BULLETIN.112

## CP62 OVERLOAD TRIPPING

The CP62 incorporates an overload circuit as part of the circuit board CP62-10. This is intended to protect the SCR's in the event of a fault such as a short across the output terminals.

EXERPT FROM DRAWING CP62-10

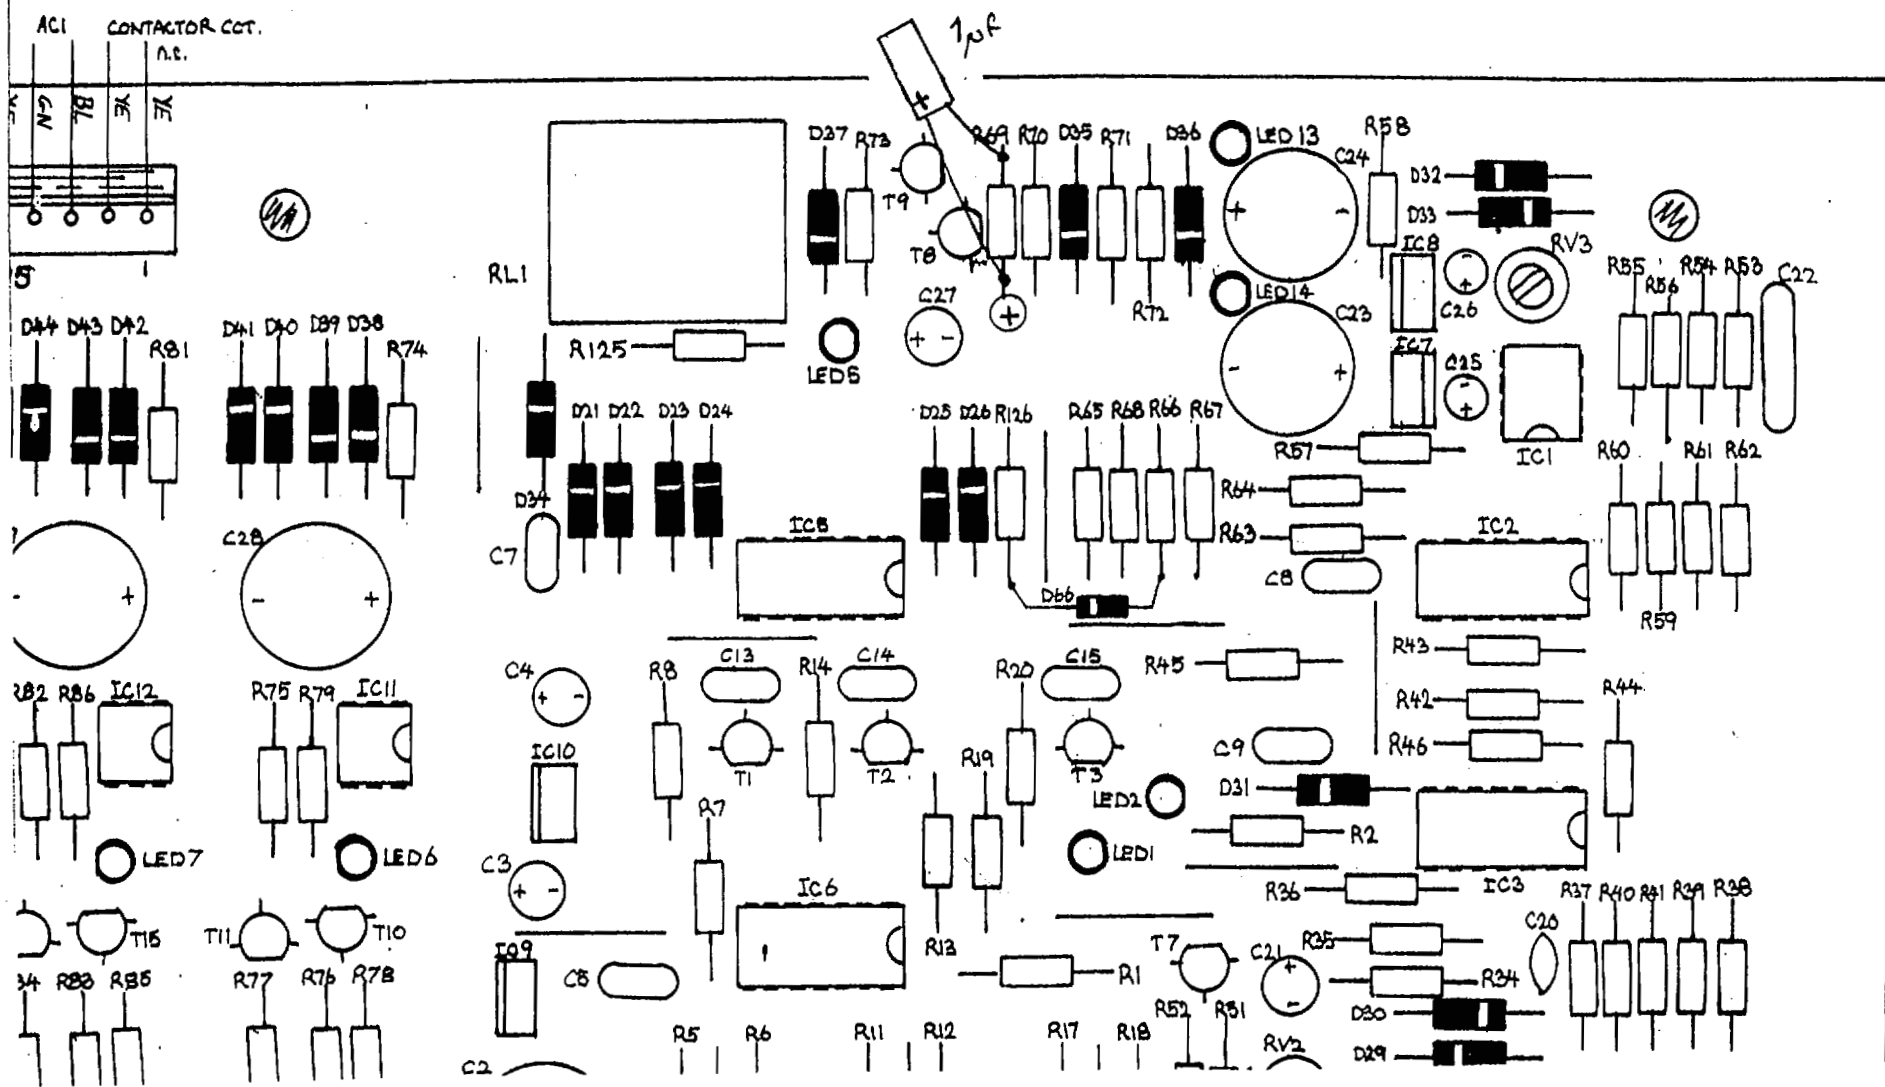
It has been found that when the machine is used at higher-end welding currents, transient spikes on the current waveform can cause nuisance tripping of the overload circuit.

This can be corrected by the addition of a  $1.0\mu f$  electrolytic capacitor across resistor R69. A suitable device in the WIA inventory is Part No. CP4-33/12 ( $1.0\mu f$ , 63VW). Refer to the drawings below for fitting positions and polarity.
